West Lynn Town Centre
Waitemata Safe Routes
Grey Lynn

Accessibility Audit

January 2018

Figure 3 - Image taken from Aecom drawings showing proposed alignment of crossing point (note TGSIs shown do not appear to have the 300mm minimum set back required)

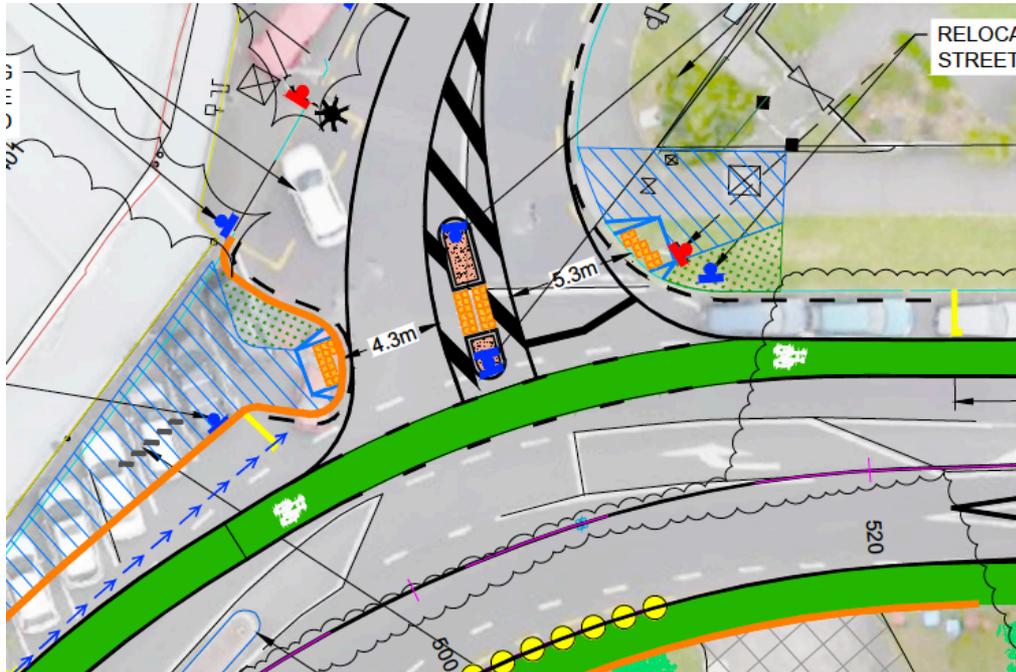
The crossing point at Warnock Street is identified in the Aecom design drawing number 60525529-SHT-RC-C-1204 to have a direct alignment created with adjustments to the footpath on the northern side of Warnock Street to align with the newly created extension on the southern side. At the time of the audit, this had not been implemented.

Providing either a dog leg island or direct alignment as proposed in design drawings will need to be implemented. The design drawing shows warning indicators but does not have any directional provided on either side of the road crossing. Given that the alignment of the footpath angle changes on the north and southern sides in order to facilitate the crossing alignment there will be a need to provide directionals that extend into the line of travel along the footpath to guide users to the crossing points.

- That realignment as proposed and/or dog-leg island to facilitate crossing point at Warnock Street is implemented.
- Directionals are provided that extend the full length of the footpath CAPT and movement zone on north and south sides of the crossing point at Warnock Street.
- That road crossing points at Hakanoa and Tutaneikai are re-assessed and consideration given to re-aligning to desire line providing consistent gradient for crossing, shelter, shortest crossing point and indented crossing point considerations.

Figure 6 - Photo showing desire line for crossing at Tutanekai Street

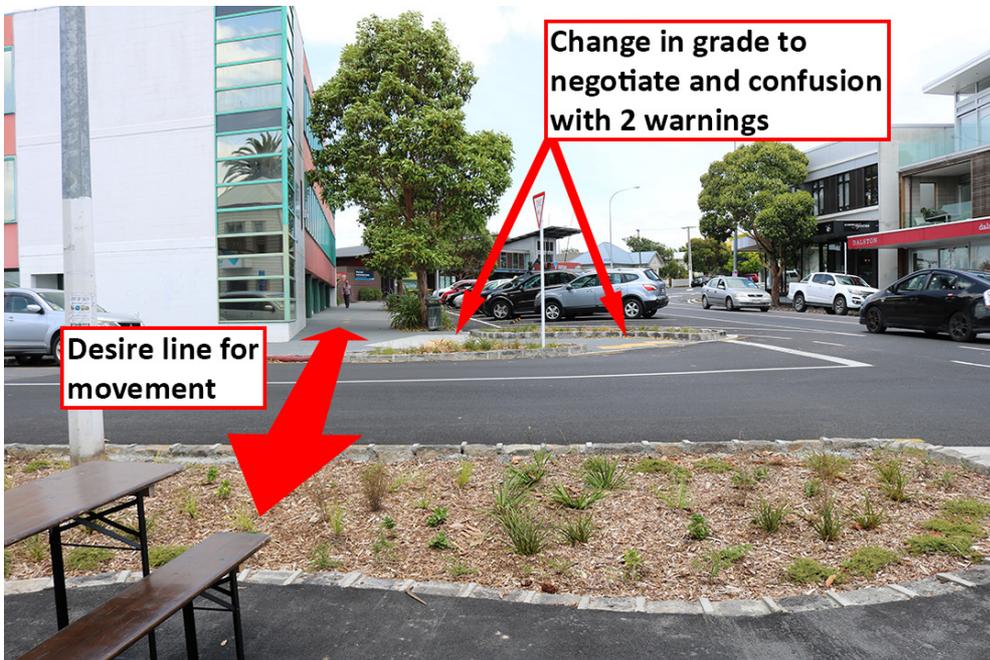
At both Hakanoa Street and Tutanekai Street, the crossing point has been extended out to the widest part of the road to provide for better visibility for pedestrians crossing the road.

Observations on site indicate that despite the provision of planted areas to guide users to the crossing locations, majority of people (those walking) continue to cross guided by the desire line of the footpath alignment.

Given the shelter provided by the existing desire line, the shorter road distance to negotiate, the more consistent and usable gradient, it is considered that in this particular instance, it may be more beneficial for the crossing point to be in alignment with the desire line.

Observations on site indicate that alongside the gradient issues associated with accessibility, that pedestrians are not using the pram crossings and continue to cross at the desire line location. As such, it would seem appropriate to reconsider the original decision and review whether there is benefit in relocating the crossing points back to the desire line for Hakanoa and Tutanekai Streets.

- 3) That road crossing points at Hakanoa and Tutanekai Streets are reassessed, and consideration given to realigning to desire line providing consistent gradient for crossing, shelter, shortest crossing point and indented crossing point considerations.

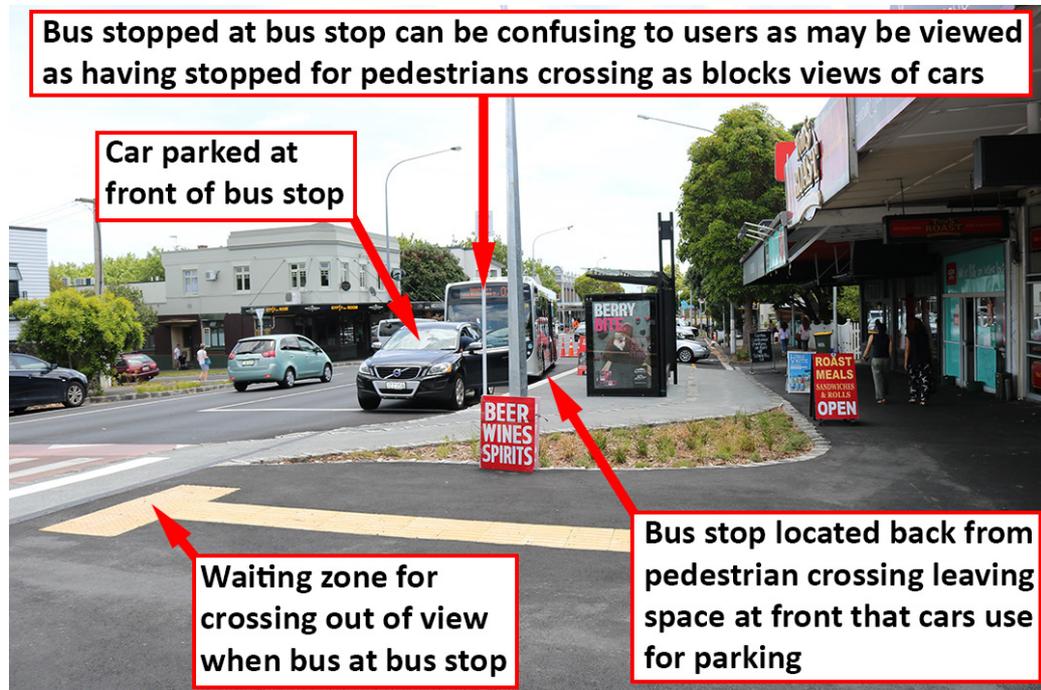
The other area where there is potential confusion is in the new location for the relocated bus stop. The bus stop has been designed as a floating bus stop with the cycle way running behind the bus stop location and the footpath. This requires bus users to walk across the cycle way to gain access to the bus stop.

The current design as implemented has little indication of who has priority and there are no directional to guide users to the bus stop. In the design drawings, the cycle way in this location is indicated to have red colouring and striped red indicators to cyclists to watch for pedestrians. To cross over to the bus stop, users have to cross two bluestone kerb edges to the cycle way. These edges have a significant number of inconsistent surface texture and the concrete grout is raised and creates a trip hazard. The edge of the cycle way needs to be tactile, but not so tactile as to create a trip hazard.

The design of the bus stop has an inconsistent approach that makes it confusing for users.

The bus stop in front of the pedestrian crossing creates confusion between the bus not moving and potential waiting vehicles yielding for pedestrians.

There are no TGSIs to located the boarding position for the bus.

The warning TGSIs at the zebra crossing do not cover the full width of the crossing.

- That consideration be given to provision of one controlled crossing point at West Lynn Town Centre.
- Reconsider location of bus stop to remove visibility issues with pedestrian crossing. If not, removed, address lack of warning and TGSIs for the bus stop.

Figure 14 - Photo showing pedestrian crossing moving into cycleway and confusing crossing waiting location also the warning tgsi need to cover the full width of the kerb otherwise can be missed.

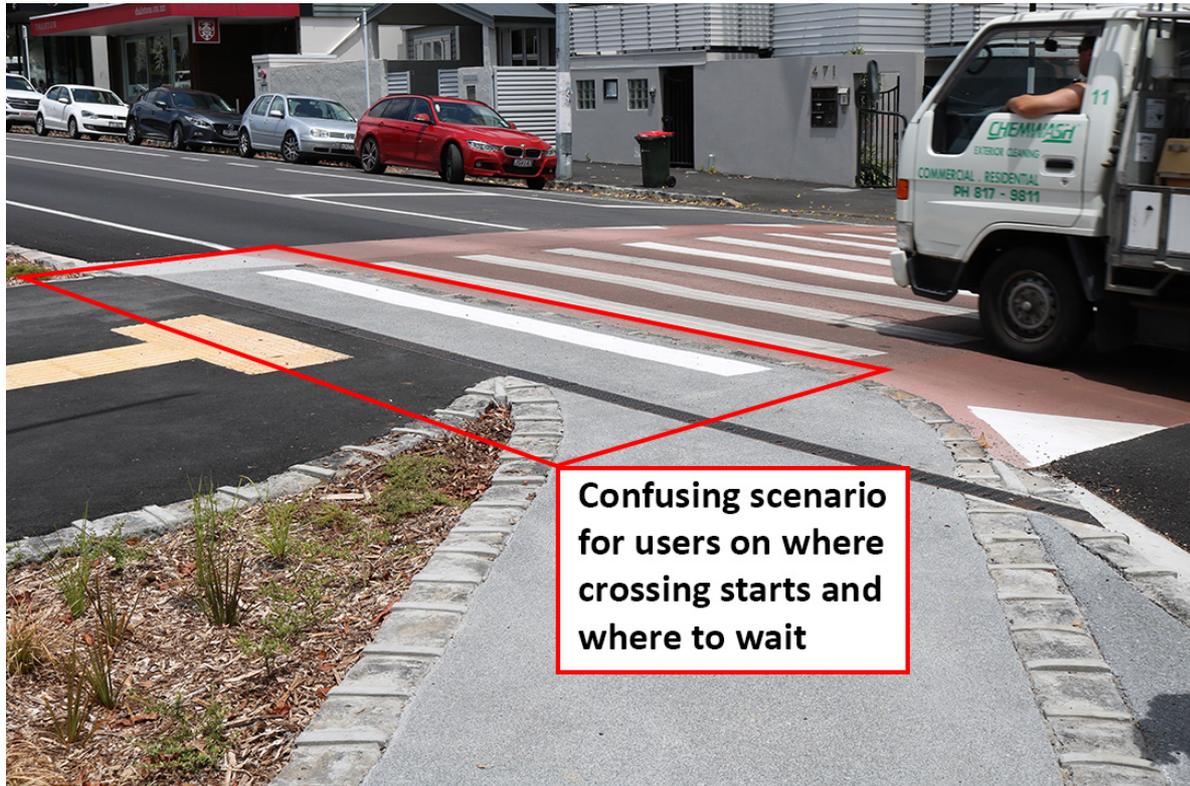
At the pedestrian crossing adjacent to Tatanekai Street, the pedestrian crossing marking enters into the cycleway. This creates some confusion for users as to where the pedestrian crossing waiting point is. For those that don't use the warning TGS1 the waiting point could be interpreted as adjacent to the white line and halfway into the cycleway – thus creating a potential hazard between pedestrians and cyclists. Once the red colouring on the cycleway is implemented as per the design drawings, this will create further confusion visually and the approachability cues for the crossing point are no longer simple and intuitive.

Figure 16 - Alternate route options for less confident users and directional TSGI should be extended to building line and ensure warning TSGI cover the full width of the crossing and match other side.

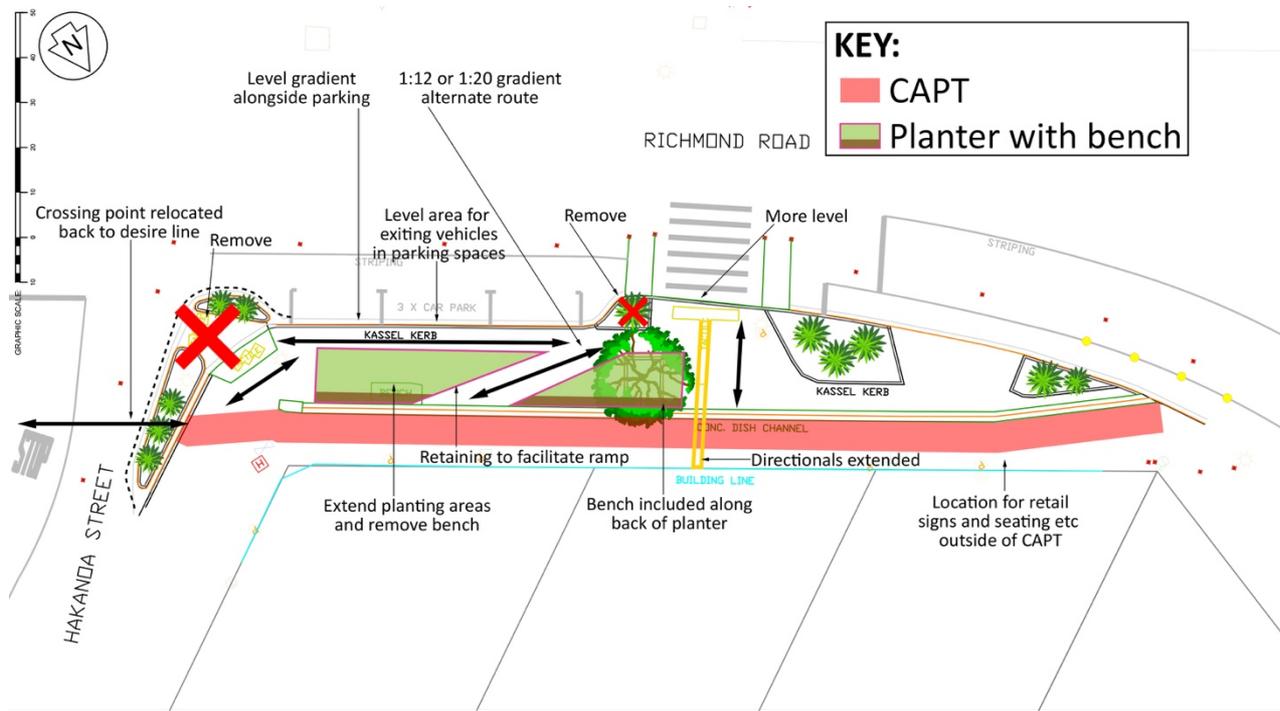
At the crossing point adjacent to Warnock Street, the approachability on the eastern side is compromised due to the significant gradient issues.

Although the existing gradient is manageable for some with limited mobility, for anyone that is less confident, has low energy or is slow moving, the steep grade will be extremely difficult to navigate. This is further exacerbated by the raised table that has further increased the gradient to be navigated. This is also a forced crossing point, as there are no other nearby options for crossing.

There is a large expanse of sloped asphalt footpath adjacent to the crossing point that could facilitate provision of some form of extended length of gradient or ramp that will provide for users that have less ability and require lower effort.

- 11) That consideration be given to provision of additional accessible parking within the Town Centre location.
- 12) The eastern side of the footpath at the Warnock Street crossing point be re-designed to provide better gradient changes that will accommodate a wide range of individual preferences and abilities.
